MEMORANDUM

To: The Design Advisory Board
From: Mary O'Neil, AICP, Senior Planner *moveil*
RE: ZP 14-1300CA/CU 85 Lakeview Terrace
Date: July 8, 2014

Request: Construction of a 2 story addition to existing single family home; remove existing shed and construct new accessory structure for accessory dwelling unit and storage.

Proposed Site Plan

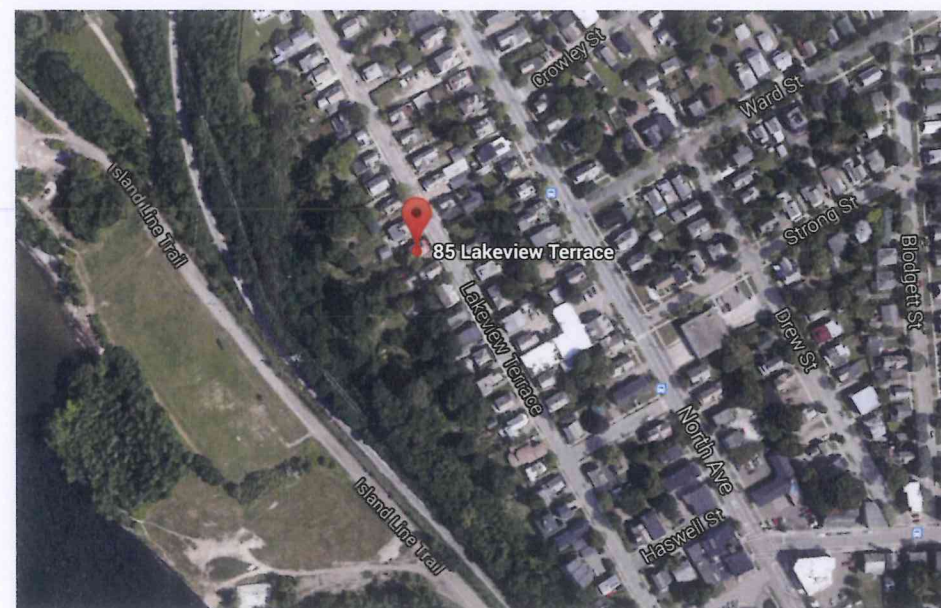
The proposed site plan illustrates a walkway from the parking area/drive to the accessory dwelling (walkways are permitted to encroach within setbacks.) There is no walkway to the primary residence from either the sidewalk or from the drive to the house. Some method of pedestrian connection will need to be illustrated for the primary residence.

The single family home requires 2 parking spaces, and the proposed accessory dwelling unit 1 parking space (Per Zoning Ordinance Amendment 13-10). Three parking spaces are illustrated on the site plan; outside the front yard setback, 2 in tandem to serve the primary residence. The existing curbscut will be utilized.

A planting box is illustrated at the foot of the stairs on modeling studies, and three unidentified trees on the site plan. No formal landscaping plan has been submitted, and further planning in that regard will be a requirement prior to review by the DRB.

A storage shed is proposed to be attached to the new accessory structure. It is assumed that this will be a location for trash/recycling as well as bicycles and other typical outdoor equipment. The applicant shall provide the intended location of trash.

1. An EPSC plan shall be approved by the City Stormwater Engineer **prior to release of any zoning permit.**
2. A pedestrian walkway shall be included between the public sidewalk and the primary residence, and/or between the parking area and the primary residence. A coverage recalculation will be required for this addition/revision.

9. If any patio, deck, or pavers are proposed for the rear of the ADU, they shall be included on the site plan and submitted coverage calculation.
10. Dimensional standards, including required setbacks, shall be met.

South
Elevation

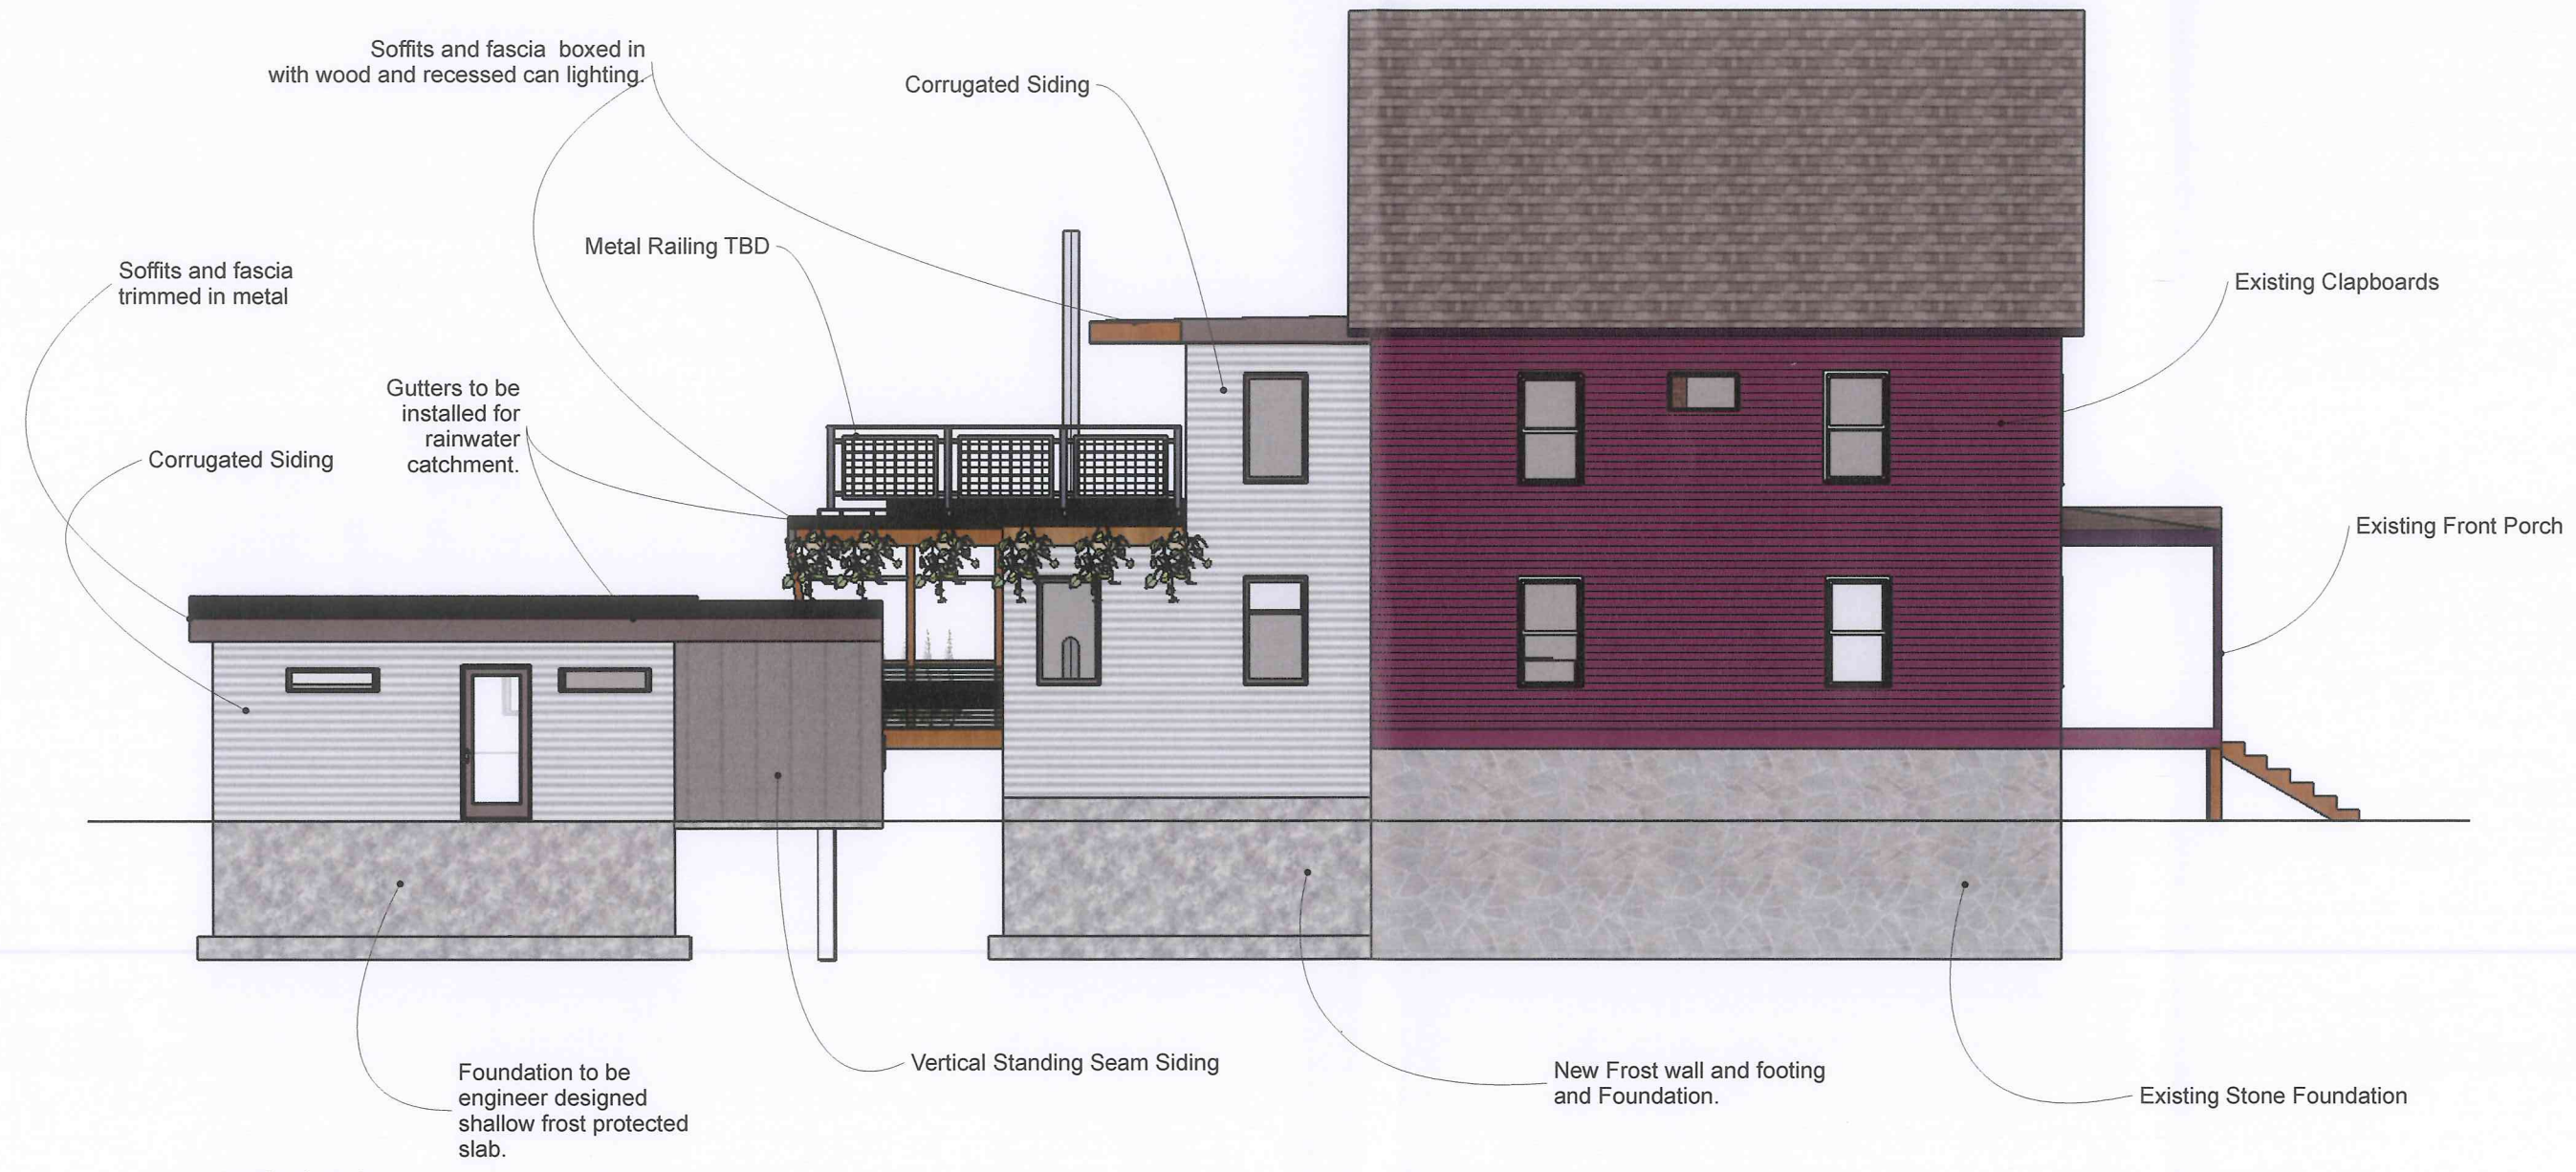
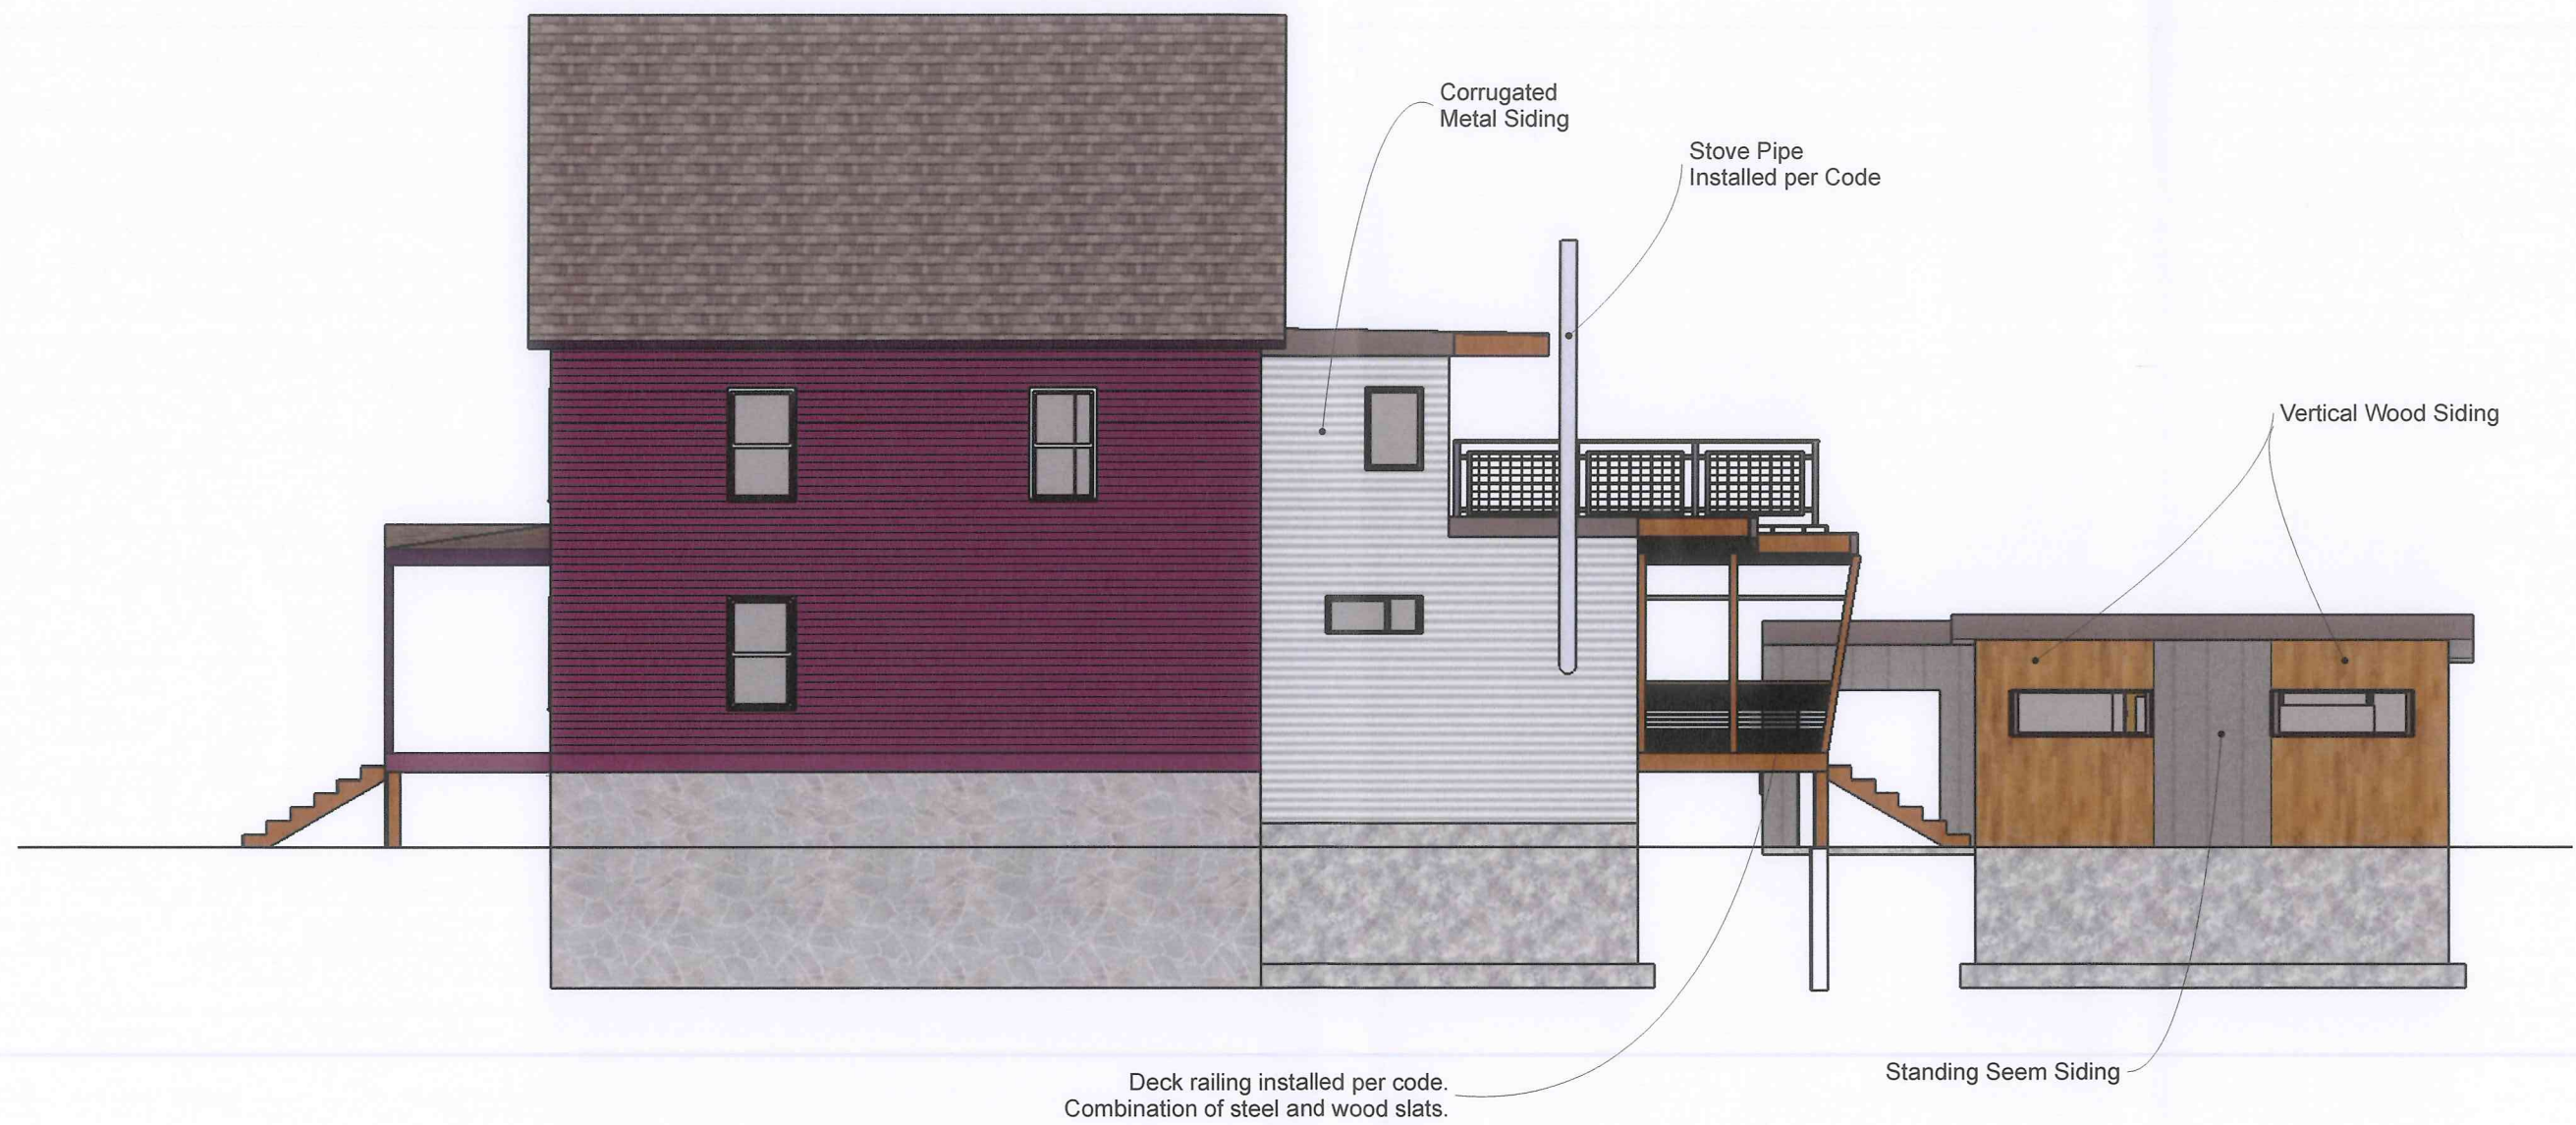
Windows and doors on the accessory structure are limited in size and number; with the largest facing west. It remains odd that the primary entrance for the ADU is facing the southerly property line (remote, and close to the property boundary), with small windows that will prohibit passive solar gain on the southerly exposure. A reassessment of this arrangement is recommended to

relocate the entrance to the east or north, with greater window glazing on the south.

It is again encouraged to move the primary entrance of the ADU off the south elevation near the property boundary toward the interior of the lot.

3. It is recommended that the primary entrance to the accessory dwelling unit be relocated from the south elevation to either the east or north to direct resident traffic toward the interior of the lot rather than against a property line. It is further suggested that a primary window would be welcome on the streetfront/east façade, as would a window to capture easterly light into the accessory dwelling unit. “Flipping” the project plan would accomplish locating the entrance on the interior, and providing a greater amount of glazing on the south elevation, increasing solar gain.

Board members discussed demolition of existing deteriorated storage shed and the southern access to the new structure; both were acceptable to board members.

1. Amend the site plan to include a walkway from the primary unit and to add landscaping.
2. Apply for and obtain a fence permit along with the current application.
3. Address inclusion of trash and recycling in the shed.
4. Meet all staff recommendations except for reversal of the south entrance.
